TRIM—DEFROSTER GRILLE LIFTING OUT OF POSITION	Article No. 01-22-4

MERCURY: 1999-2002 COUGAR

Figure 1 - Article 01-22-4

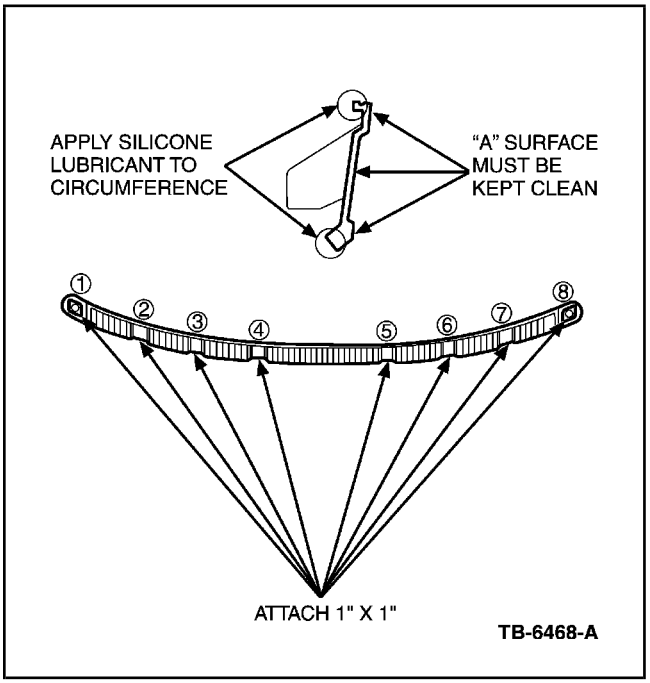
Some vehicles may exhibit a condition where the defroster grille edges lift out of the dash pad. System performance is not affected. This may be caused by the design of the defroster grille.

1. Remove defroster grille from Dash Pad and make sure it is not damaged.
2. Clean all mating surfaces on the Dash Pad and defroster grille as indicated in Figures 1 and 2 using Isopropyl Alcohol wipes (part ZC-4 or equivalent).
3. Attach six of the 1″x1″ self adhesive dual lock pads to the center of defroster grille positions 2,4,5,7 and on molded round boss in positions 1 and 8 (Figure 1).
4. Attach four 3/4″x1″ self adhesive dual lock pads to the four connection bridges and two 1″x2″ self adhesive dual lock pads at the ends of the Dash Pad (Figure 2).
5. Apply a thin layer of Silicone Brake Caliper Grease and Dielectric Compound (XG-3) to the outer edge of the defroster grille (Figure 1).
